Change Order

Project:  
20-15092 WILCO ANNEX - GC  
151 WILCO WAY  
GEORGETOWN, TX

Change Order: 13  
Date: 7/11/2018  
Architect's Project:

2 UPPER CEILING PLAN - COURTROOM JP201  
 1/4" = 1'-0"

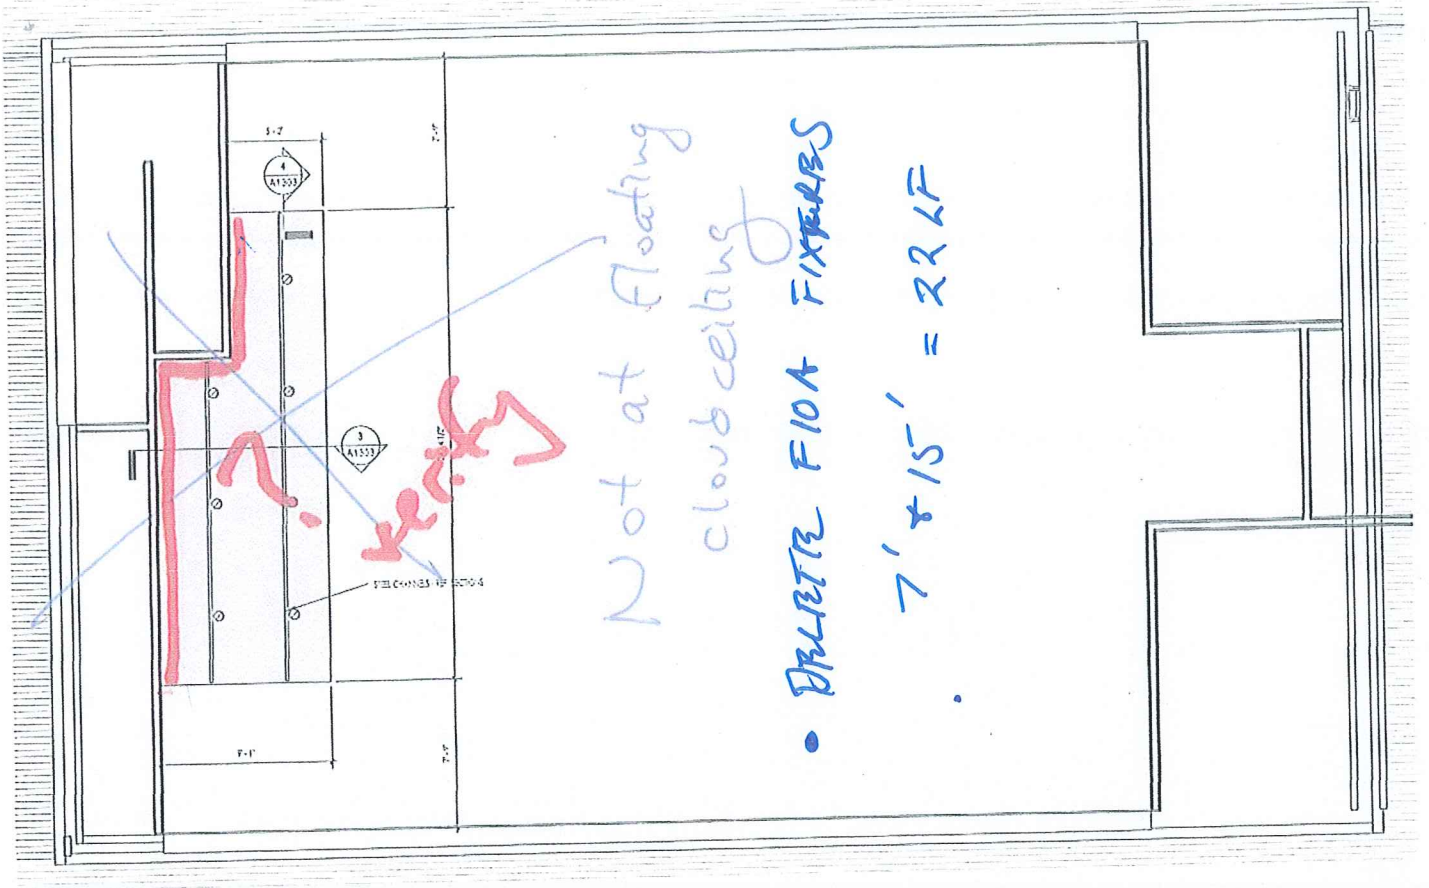
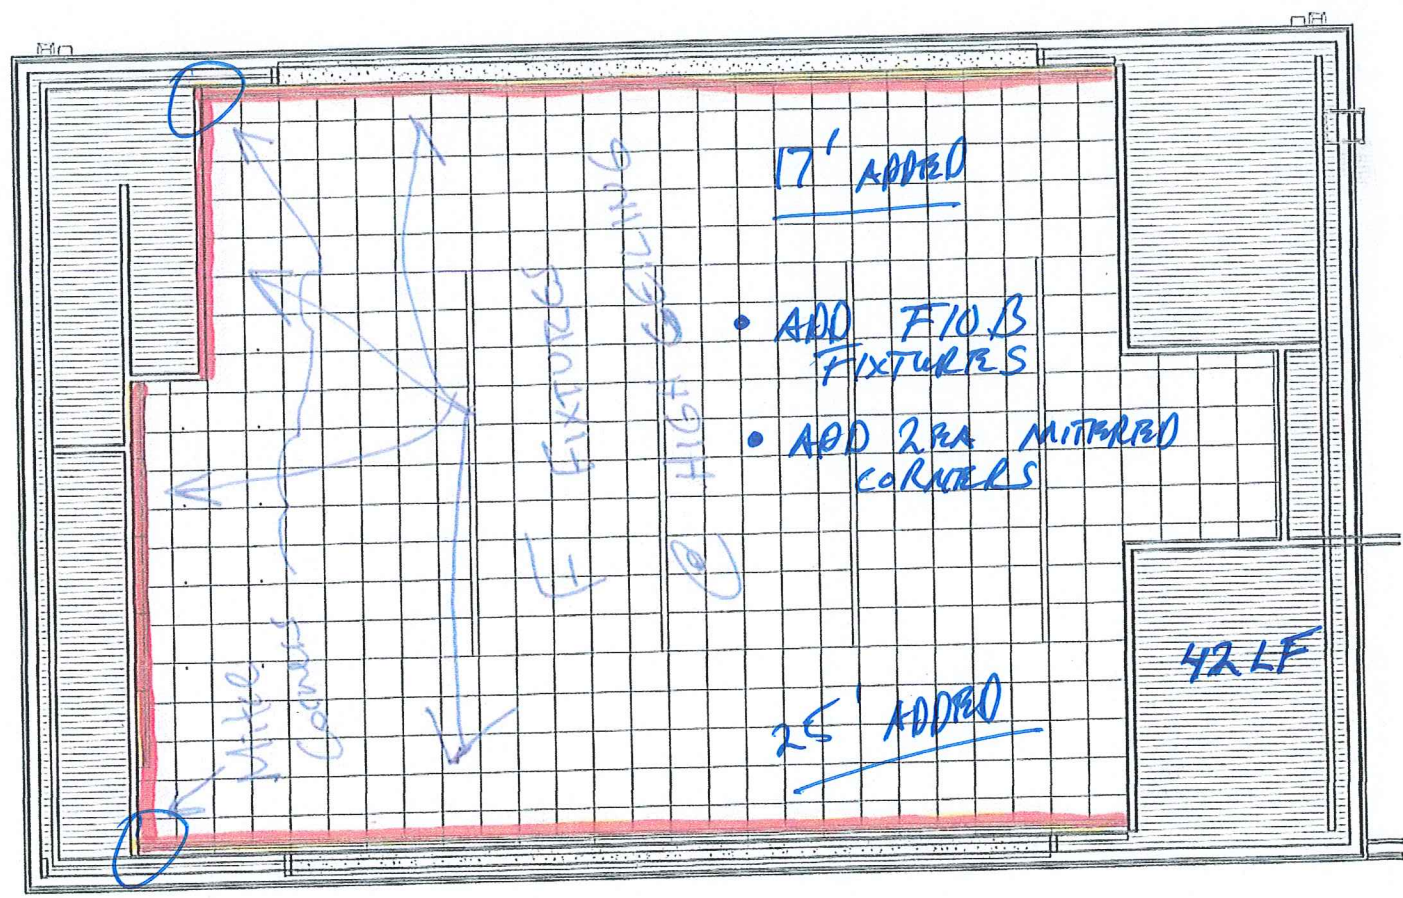
Description: Revise F Fixture Layout

We are pleased to offer the following specifications and pricing to make the following changes:  
Pricing per Architect's preferred layout of the F-type fixtures in the high ceiling of the Courtroom JP201

DOOR #122

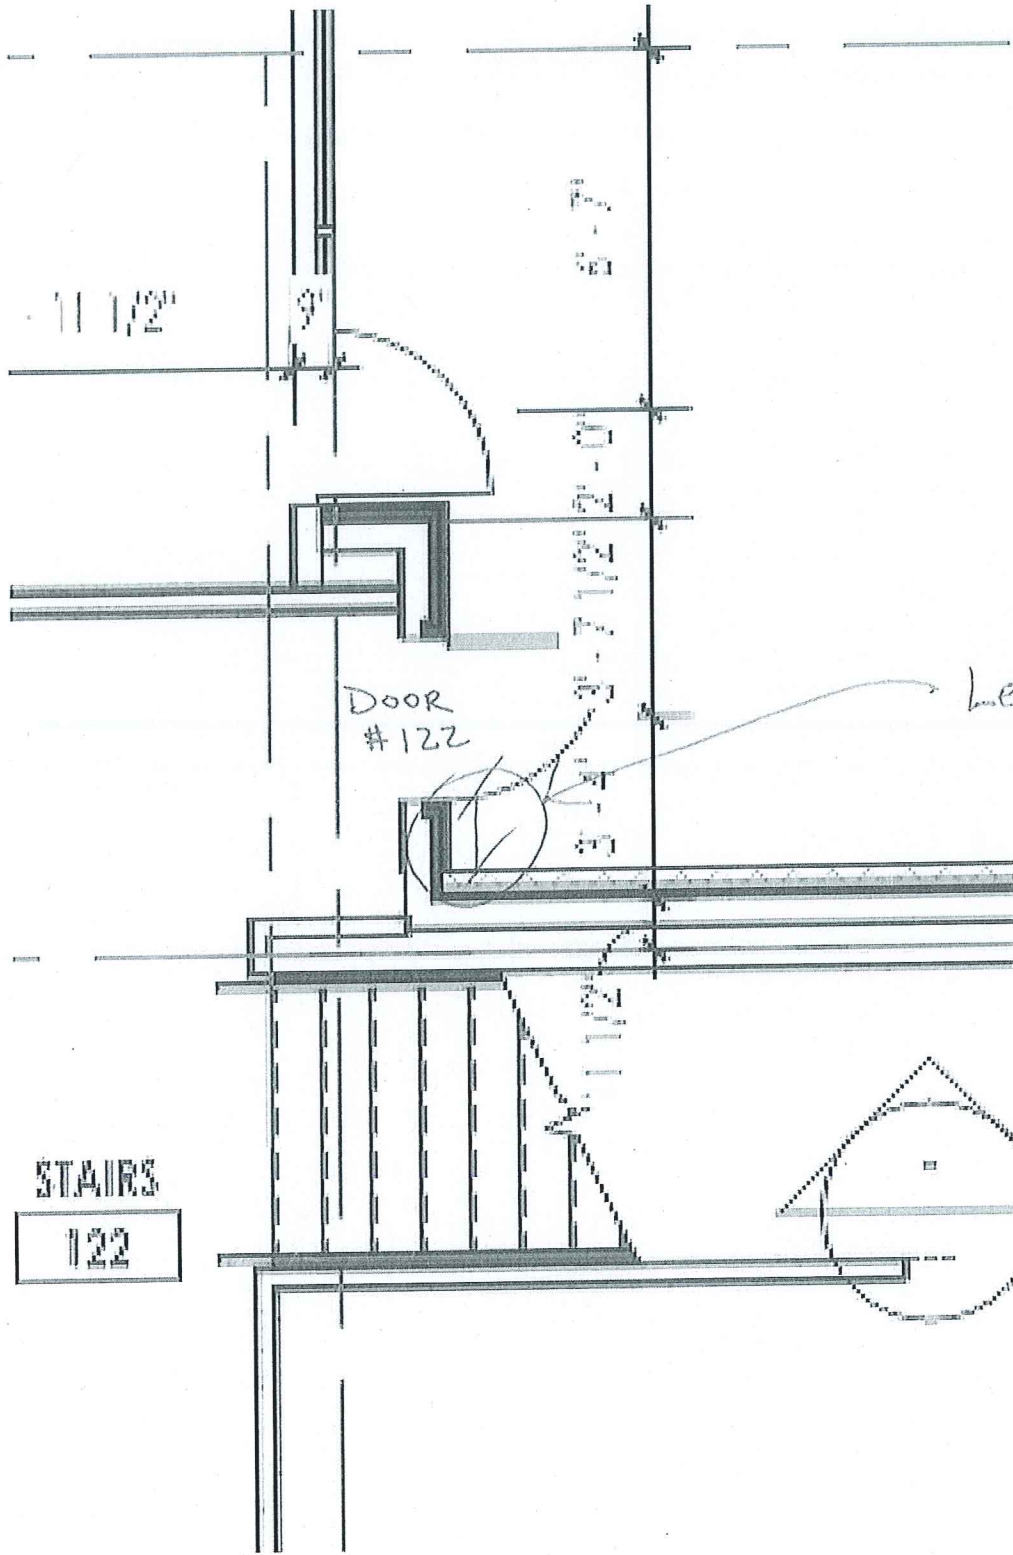
1. Please confirm the LH swing, as per the plans. There will not be the requisite 18" clearance on the exterior strike side of the door. The hollow metal frame is already on site, but can be field modified to make it an RH swing.

Yes. Door must be a RH swing to accommodate ADA. Please make the requested door swing change.
